Water and Wastewater Study Combined

PRELIMINARY Basis of Design Report	CITY OF					
		SCOTTSDALE					
	ACCEPTED AS NOTED						
	REVISE AND RESUBMIT	9379 E San Salvador Dr. Scottsdale, AZ 85258					
	Disclaimer: If accepted; the preliminary approval the condition that a final basis of design report w submitted for city review and approval (typically PP case). The final report shall incorporate furthe design and analysis requirements as defined in t standards and policy manual and address those the preliminary review comments (both separate herein). The final report shall be submitted and a the plan review submission. For questions or clarifications contact the Water Planning and Engineering Department at 480-31	ill also be during the DR or er water or sewer he city design items noted in and included approved prior to Resources					
	BY Idillon DATE	5/11/2020	2	Anna	Ninc	orino	<u>.</u>
	Address comments below and herein BOD. Conform to stipulations listed.	on a final	planr

SOUTHDALE

FINAL WASTEWATER BASIS OF DESIGN REPORT

Preliminary Water Plans

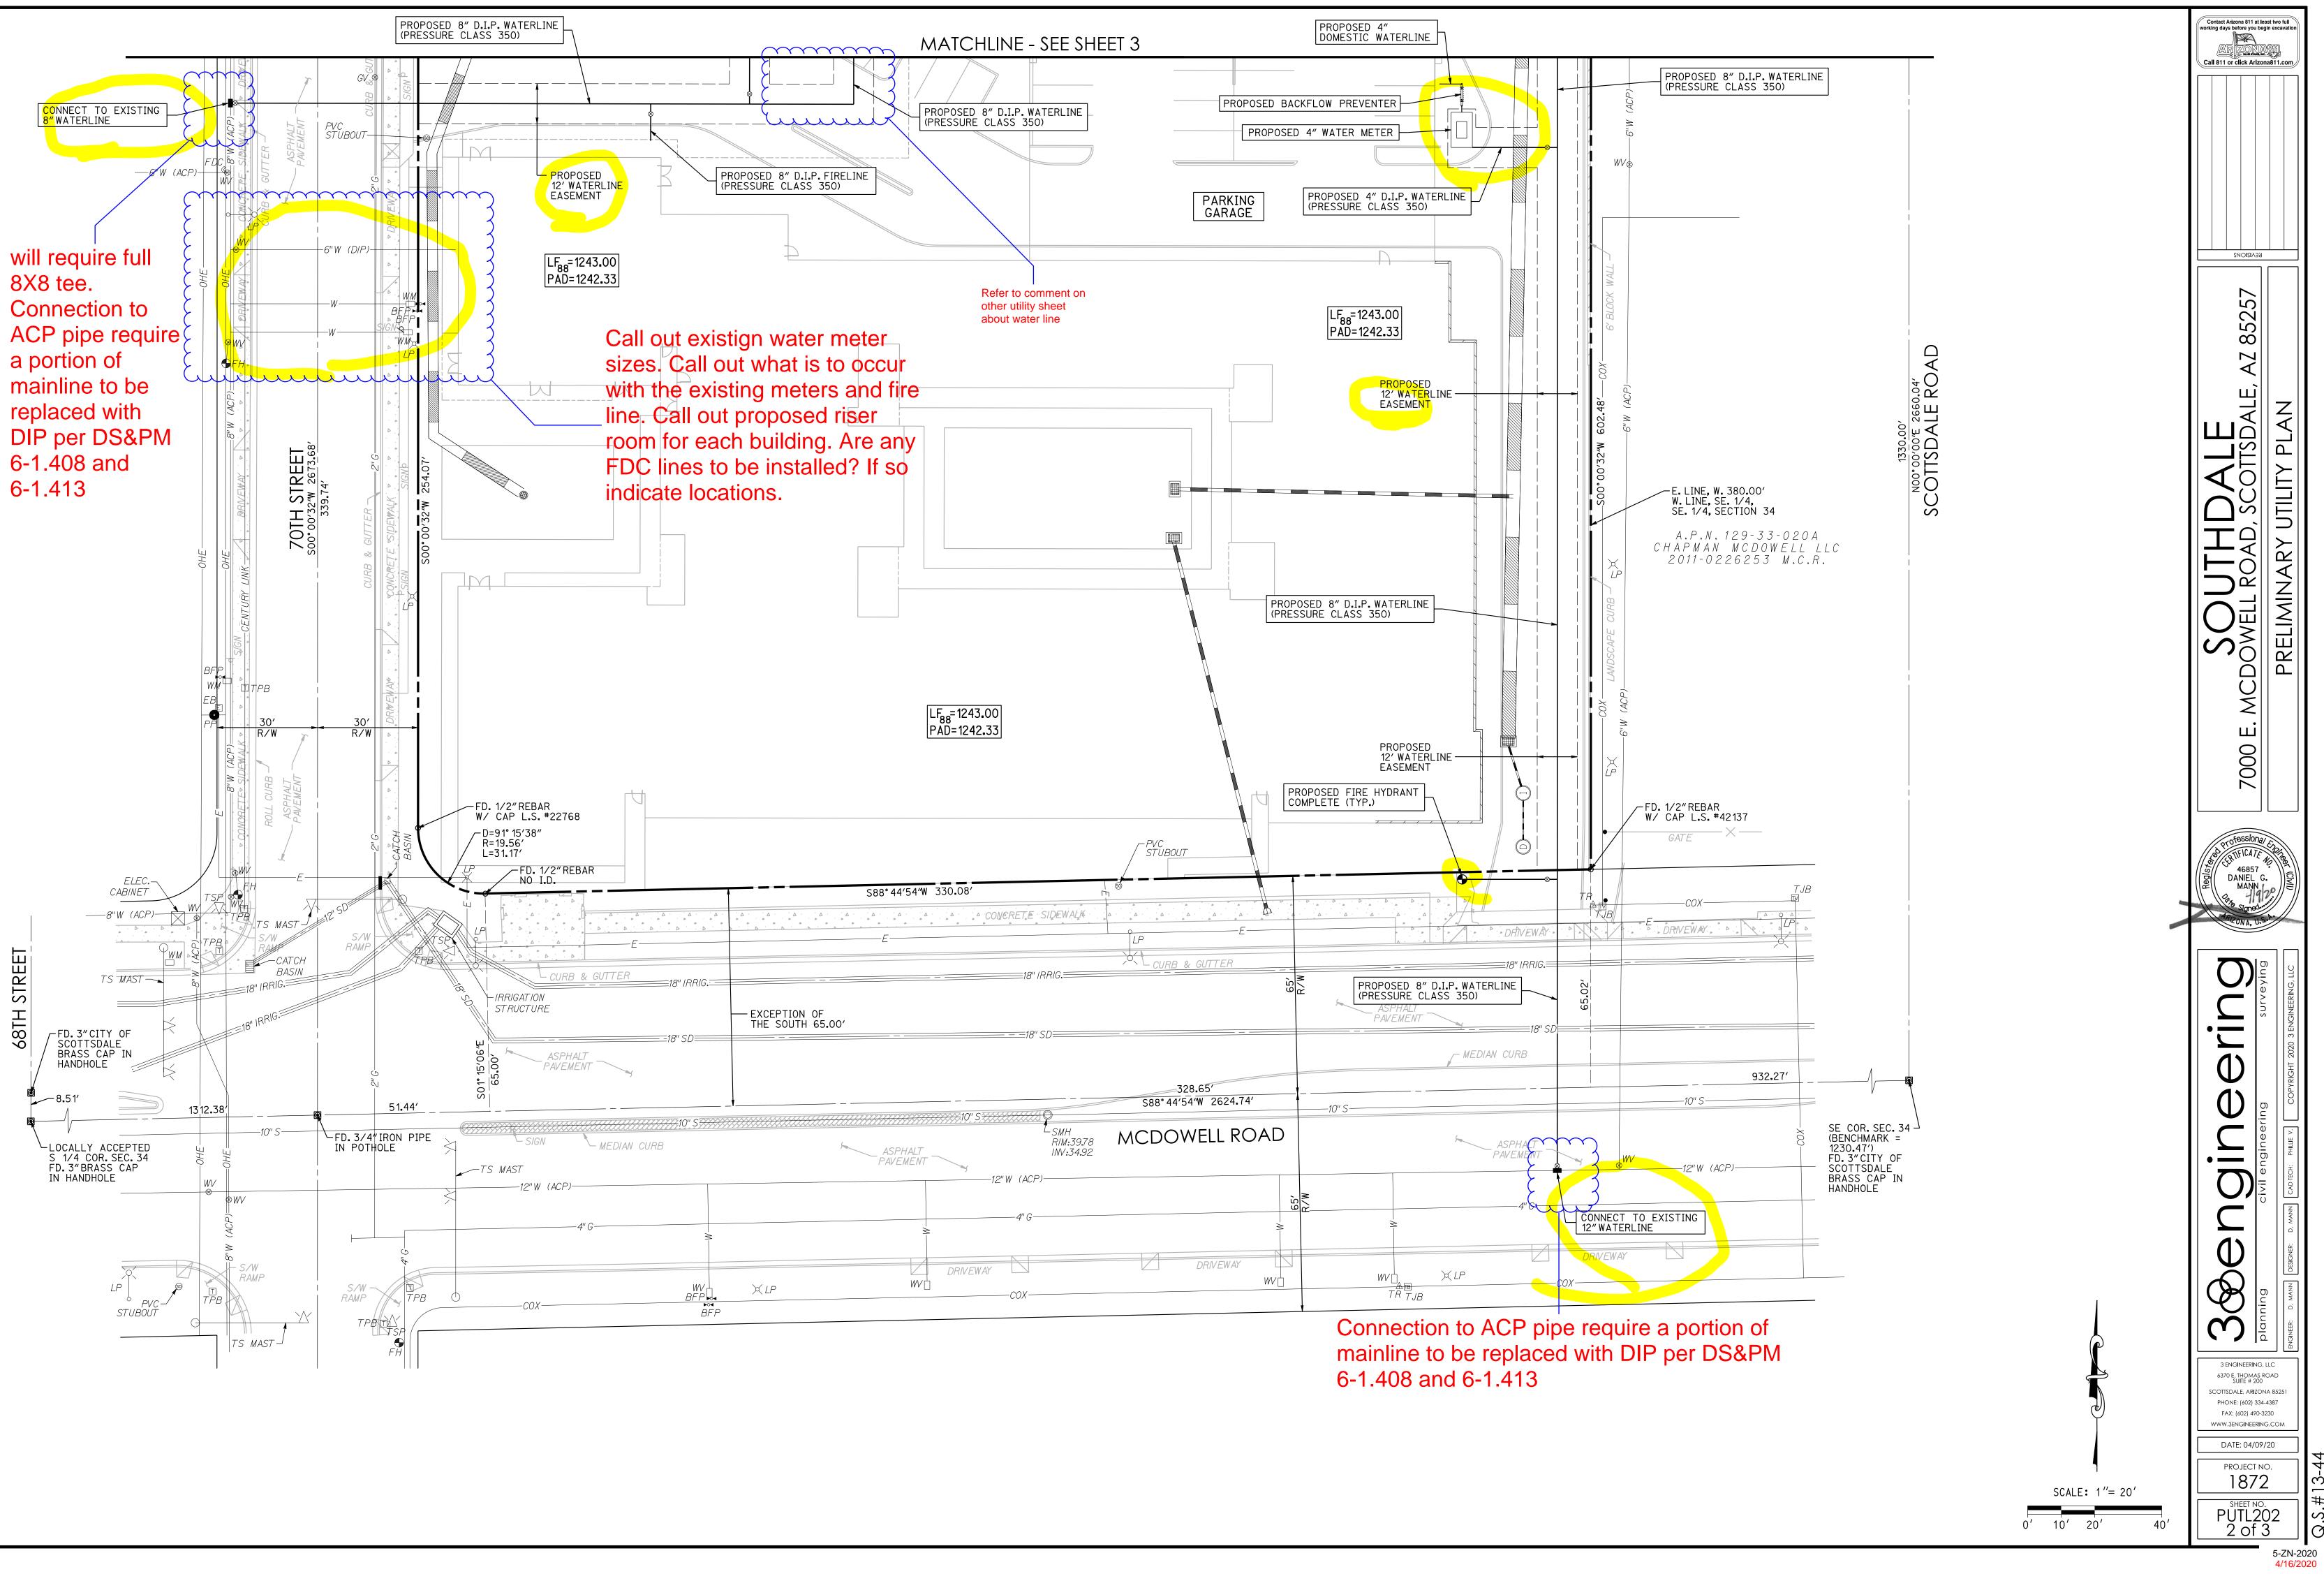
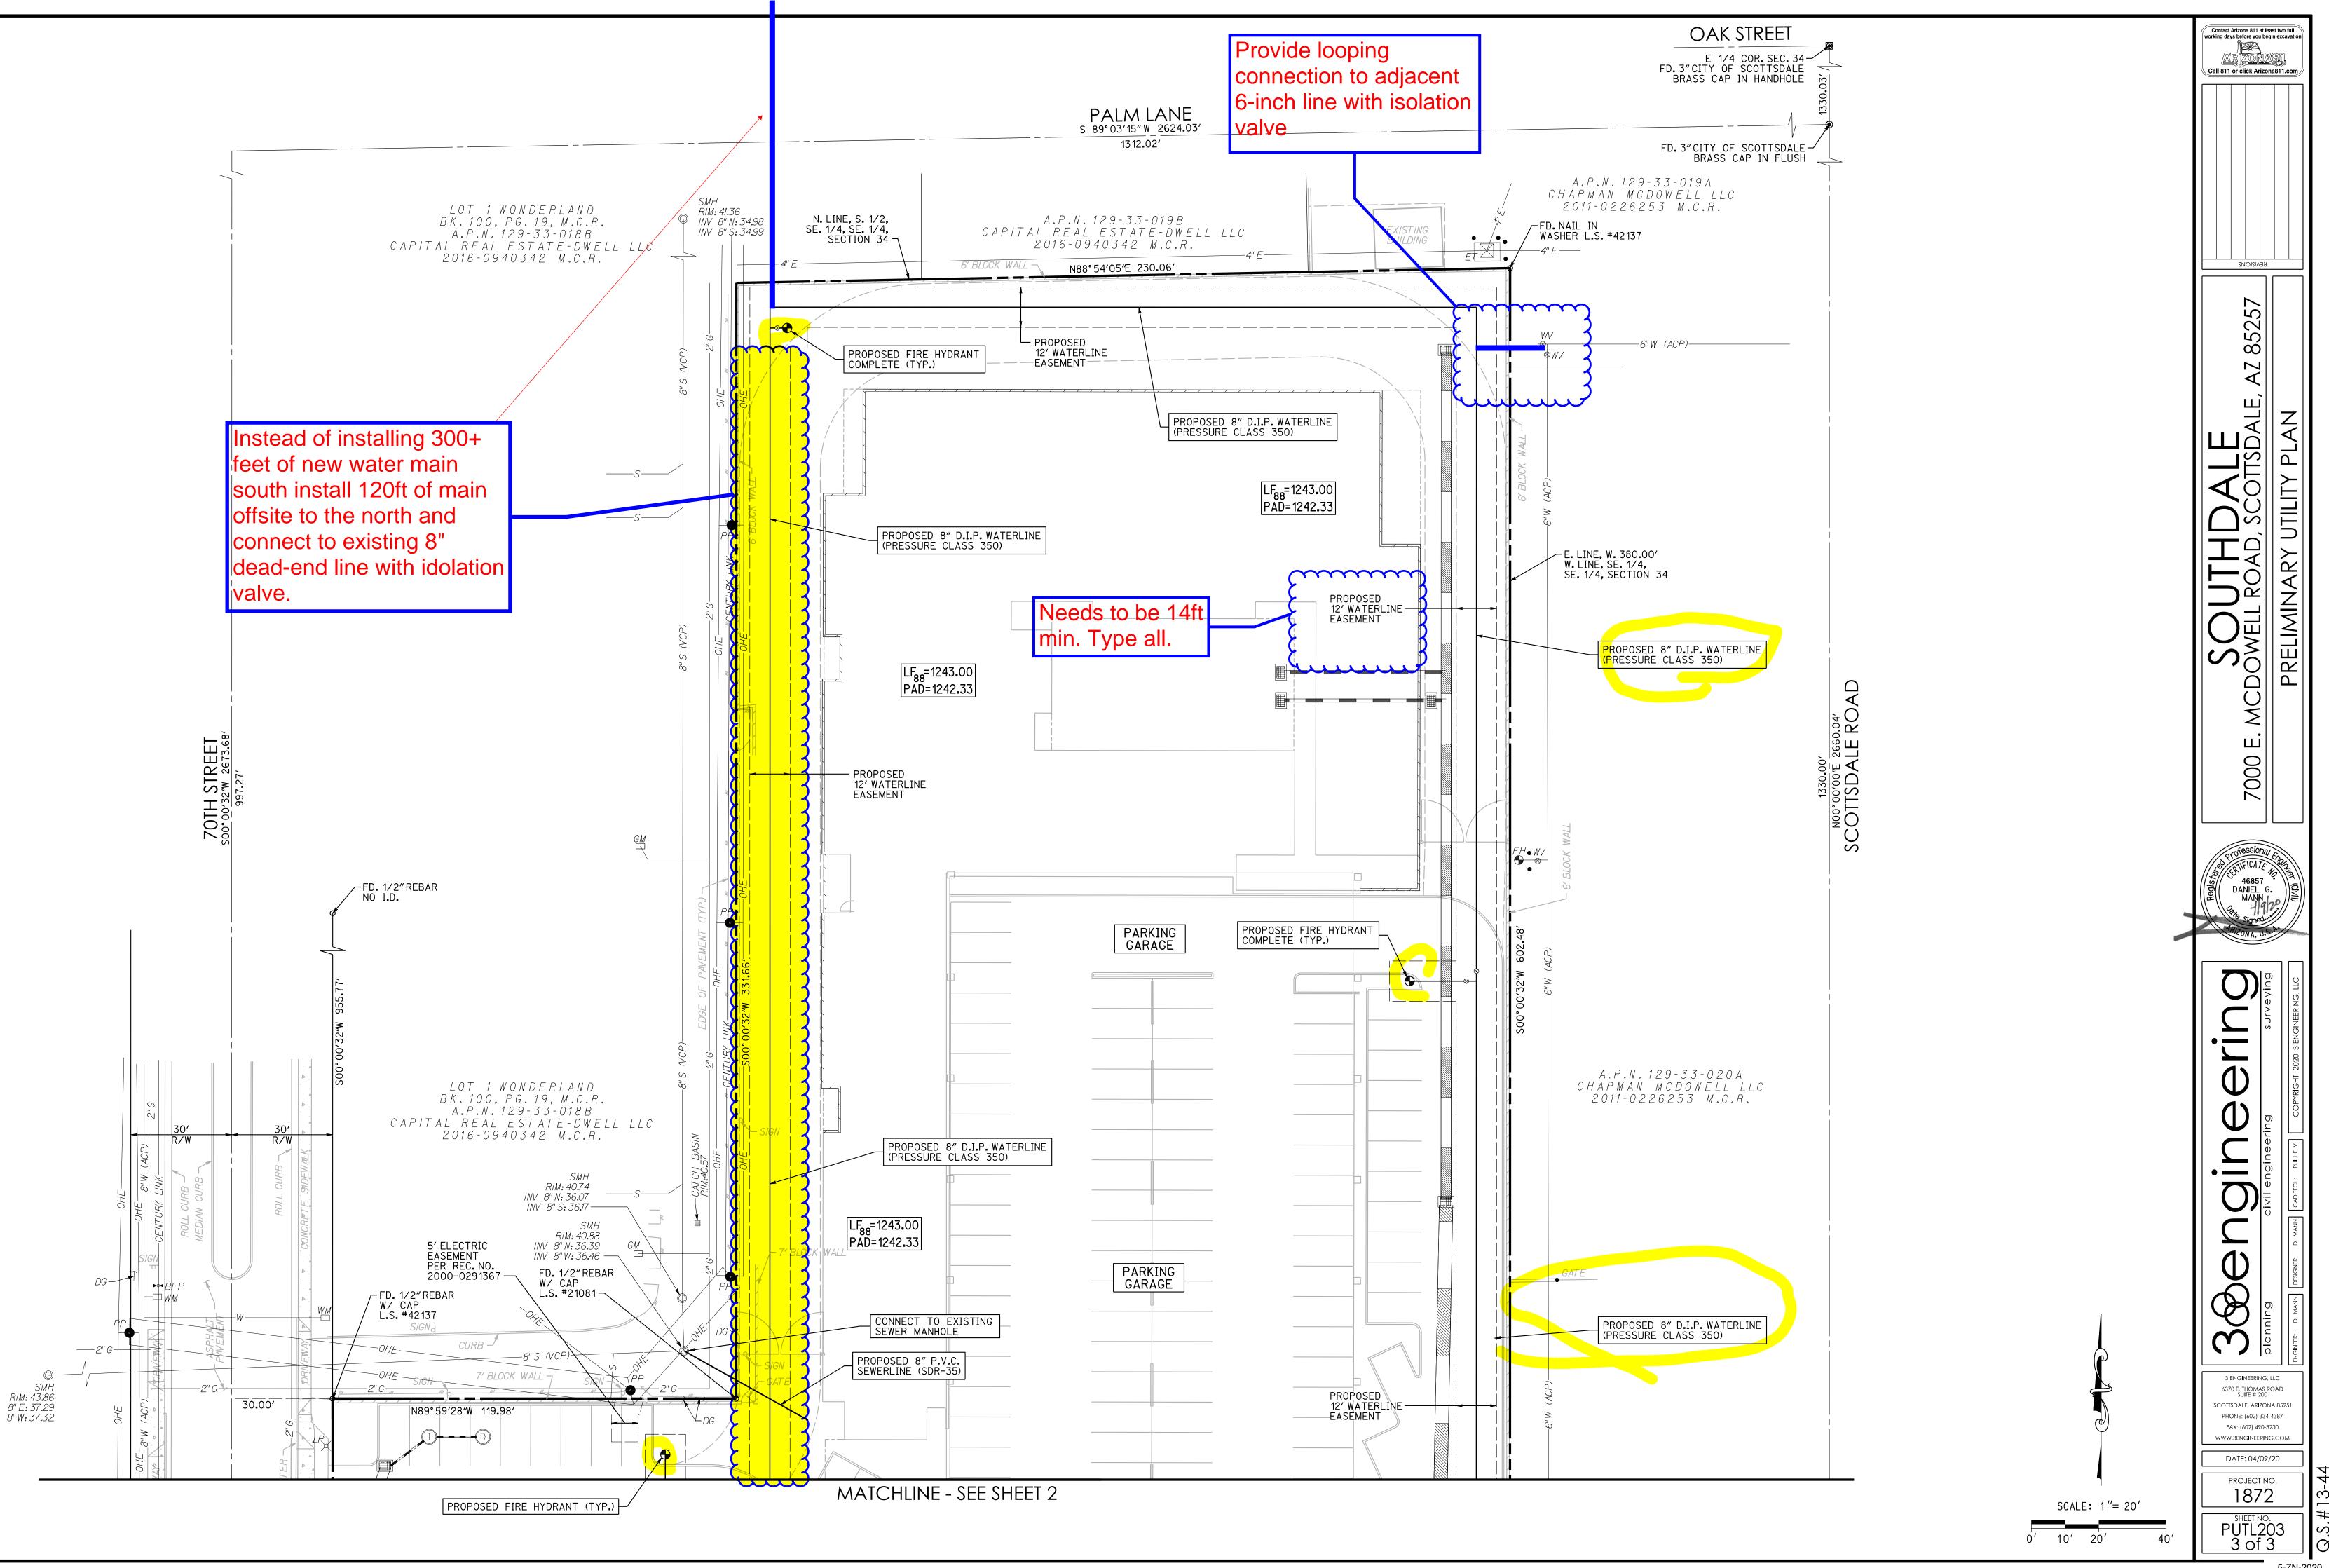
4) Call out existing water meter sizes on utility plan. Call out what is to occur with the existing meters and fire line. Note that only 1 meter can service each new building.

6) Confirm fire flow required. Value included seems too high 7) Based on hydrant flow test provided there are no capacity concerns. However, water modeling included is invalid and will need to be revised in final BOD. Set reservoir HGL for each scenario using supply curve point from hydrant flow test at required fire flow (or use pump that changes dynamically to simulate supply curve). Fire flow should only be split to a maximum of two worst-case hydrants for modeling purposes. 8) Confirm new water meter sizing. If 3" and larger call out on utility plan that a meter vault per COS detail 2345 has to be used.
